Charlotte Department of Transportation

Memorandum

Subject: Rezoning Petition 14-005: Approximately 0.39 acres located on the north side of Central Avenue between St. Julien Street and Westover Street.

Figure 1

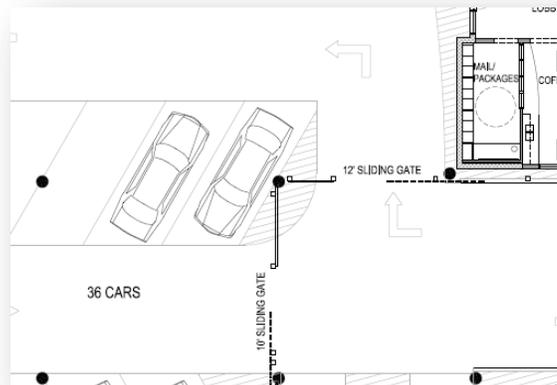
1. It appears that the building orientation and property owner locations are shown incorrectly on sheet RZ.01. We request the petitioner verify the existing conditions survey information.
2. In locations where the sidewalk abuts the proposed building, we request the petitioner increase the proposed sidewalk dimension from 6' to 8' along the entire site.
3. We request the petitioner adjust the proposed security gate pole location (Figure 1). As shown, it does not appear that a parked car door could open completely without hitting the pole.
